**SUNDRY NOTICES AND REPORTS ON WELLS**  
(DO NOT USE THIS FORM FOR PROPOSALS TO DRILL OR TO DEEPEN OR PLUG BACK TO A DIFFERENT RESERVOIR. USE "APPLICATION FOR PERMIT" (FORM C-101) FOR SUCH PROPOSALS.)

*Mexbourne Oil Company***COMPLETION PROCEDURE**

**Wellname: Lovelace 27 Fee #2**

Action 374063

Lovelace 27 Fee #2

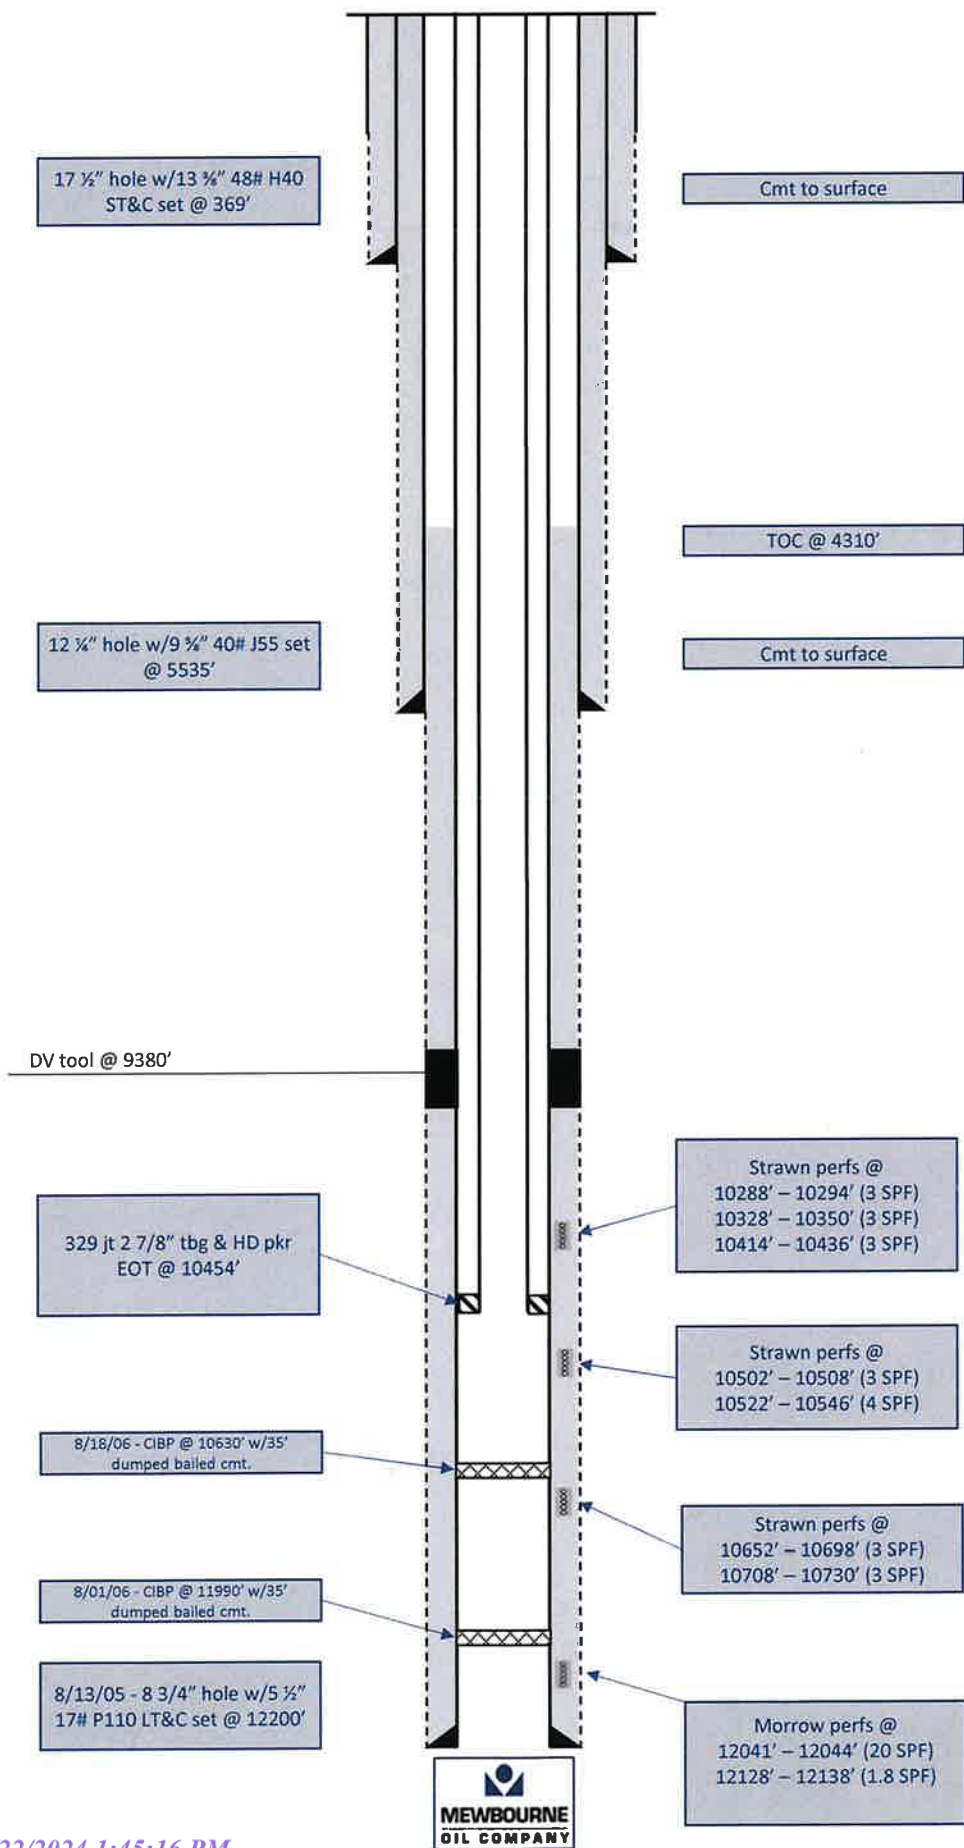
- 1) MIRU BCM turnkey plugging crew.
- 2) ND WH, NU BOP.
- 3) Release pkr & POOH LD pkr
- 4) Rack and tally 2 7/8" work string
- 5) RIH w/ 5 1/2" CIBP & set @ 10230'. **Test Casing 500psi/30min - bubble test - Run CBL to surface** Top Perf @ 10288'.

- 6) Circ hole with 9#/gal plug mud (MLF).
- 7) Spot **45** sks Class H neat cmt ( $\pm 200'$ ) on top of CIBP. WOC **6** hrs & tag @ or above **9870'**. - **T Penn**

- 8) **Spot 15 sx cmt**
- 9) LD pipe to 9430' (DV tool @ 9380')
- 10) Spot 25 sks Class H neat cmt ( $200' \pm$ ). WOC **6** hrs & tag @ or above 9330'.
- 11) LD pipe to 8916' (Wolfcamp @ 8866')

- 12) Spot **50** sks Class H neat cmt ( $200' \pm$ ). WOC **6** hrs & tag @ or above **8500'**.
- 13) POOH w/tbg.
- 14) RIH w/wireline & perforate 5 1/2" csg @ 5585' (Inter. shoe @ 5535' & Bonespring @ 5524').

Created By	Condition	Condition Date
gcordero	CBL must be submitted to OCD via OCD Permitting prior to submitting C-103P	8/22/2024
